TOWN OF HORIZON CITY
Planning and Zoning Commission Staff Report

Case No.: SDF26-0002 Verdancia Unit 4 Preliminary Phase 1
SDF26-0003 Verdancia Unit 4 Preliminary Phase 2

Application Type: Final Plat
P&Z Hearing Date: September 21, 2026
Staff Contact: David Ruiz
915-852-1046 Ext. 404; druiz@horizoncity.org
Address/Location: North of Eastlake Blvd. and East of Paseo del Este Blvd.
Nearest Park: Horizon Mesa Park
Nearest School: Desert Hills Elementary, Horizon Middle School and Horizon High School

**PROPOSED TYPICAL 54' ROW STREET SECTION DETAIL
(RESIDENTIAL SUB-COLLECTOR)**
SCALE: N.T.S.

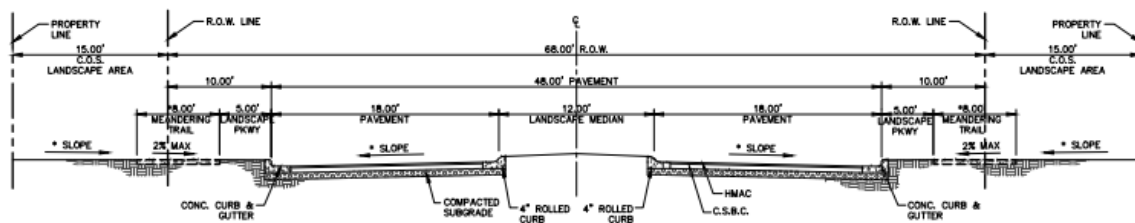
1. Modification from a 52-ft residential sub-collector street right-of-way to a 54-ft street right-of-way at all local residential sub-collector streets. The 54-ft street right-of-way will consist of two 5-ft parkways, two 5-ft wide concrete sidewalks and a 34-ft wide pavement structure with curb & gutter.

**PROPOSED TYPICAL 68' ROW STREET WITH C.O.S. TRAIL SECTION DETAIL @ ENHANCED ENTRANCE
(DUNE FLOWER PARKWAY RESIDENTIAL COLLECTOR)**
SCALE: N.T.S.

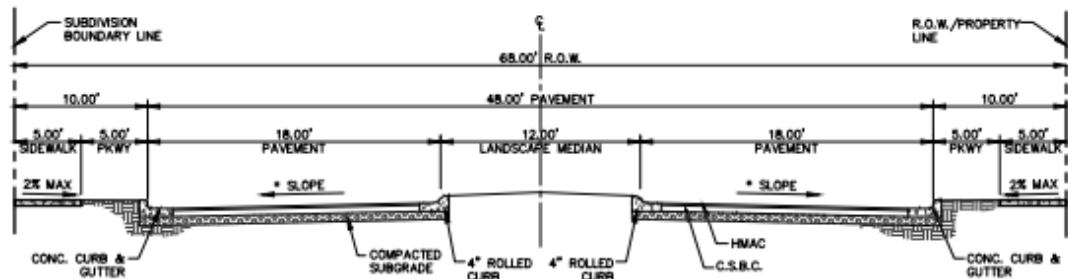
3. Modification to use a 68-ft residential collector with meandering trails at enhanced neighborhood entrances abutting common open space lots. The 68-ft street right-of-way will consist of two 5-ft parkways, 36-ft wide pavement structure with curb & gutter, a 12-ft raised landscape median and two 8-ft wide meandering trails. The 8-ft trails will meander within the street right-of-way parkway area and the adjacent 15-ft common open space landscape lot. This will provide a visually appealing and safe walking trail along this corridor. Landscape areas will be maintained by the HOA.

**PROPOSED TYPICAL 68' ROW STREET SECTION DETAIL @ ENHANCED ENTRANCE
(DESERT MIST DRIVE RESIDENTIAL COLLECTOR)**
SCALE: N.T.S.

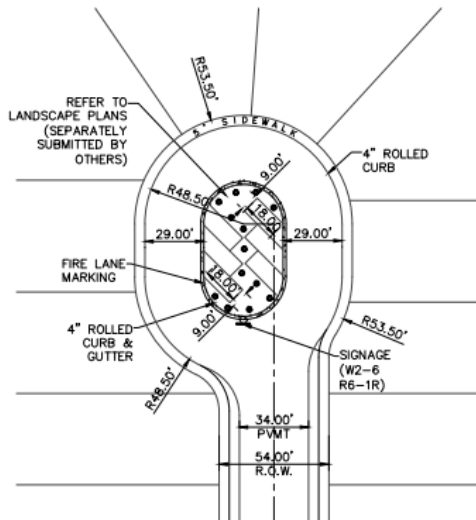
2. Modification to use a 68-ft residential collector at enhanced neighborhood entrances. The 68-foot street right-of-way will consist of two 5-ft parkways, two 5-ft wide concrete sidewalks, two 18-ft wide pavement structures and a 12-ft raised landscape median with curbs & gutter. Landscape areas will be maintained by the HOA.

TYPICAL CUL-DE-SAC LAYOUT

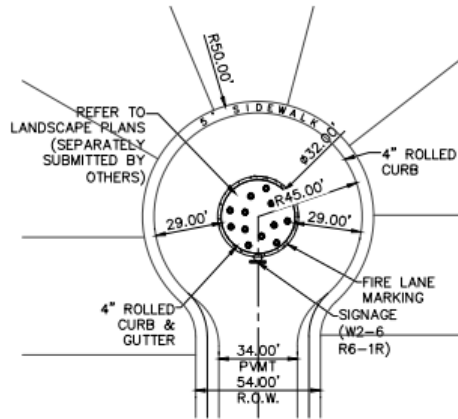
4. Modification to use 50-foot radius Cul-de-Sac streets with interior landscape islands and outside travel lane roadway width of 29-feet. The proposed cul-de-sac and landscape islands will enhance the neighborhood character, reduce the impervious surface, aid to eliminate typical cul-de-sac "stack" parking and maintain adequate room for emergency vehicle turning movement. Landscape areas will be maintained by the HOA.

5. Variance from a 50-foot radius Cul-de-Sac street to a 53 ½ -foot radius cul-de-sac with interior parking/landscape islands and outside travel lane roadway width of 29-feet. The proposed cul-de-sac and parking/landscape islands will enhance the neighborhood character, reduce the impervious surface, aid to eliminate typical cul-de-sac "stack" parking while maintaining adequate room for emergency vehicle turning movement. Landscape areas will be maintained by the HOA.

**PROPOSED TYPICAL 54' ROW STREET SECTION DETAIL
(RESIDENTIAL SUB-COLLECTOR)**

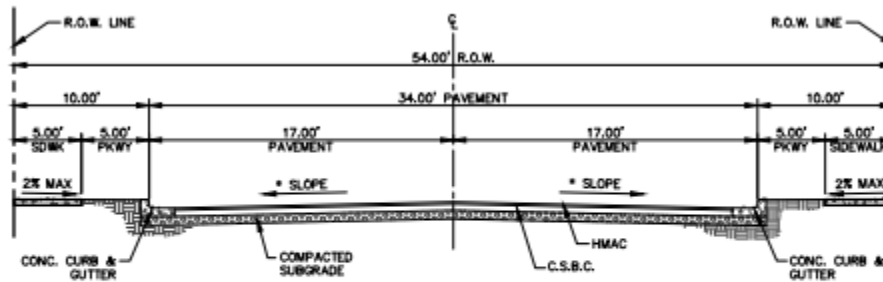
1. Modification from a 52-ft residential sub-collector street right-of-way to a 54-ft street right-of-way at all local residential sub-collector streets. The 54-ft street right-of-way will consist of two 5-ft parkways, two 5-ft wide concrete sidewalks and a 34-ft wide pavement structure with curb & gutter.
2. Modification to use 50-foot radius Cul-de-Sac streets with interior landscape islands and outside travel lane roadway width of 29-feet. The proposed cul-de-sac and landscape islands will enhance the neighborhood character, reduce the impervious surface, aid to eliminate typical cul-de-sac "stack" parking and maintain adequate room for emergency vehicle turning movement. Landscape areas will be maintained by the HOA.
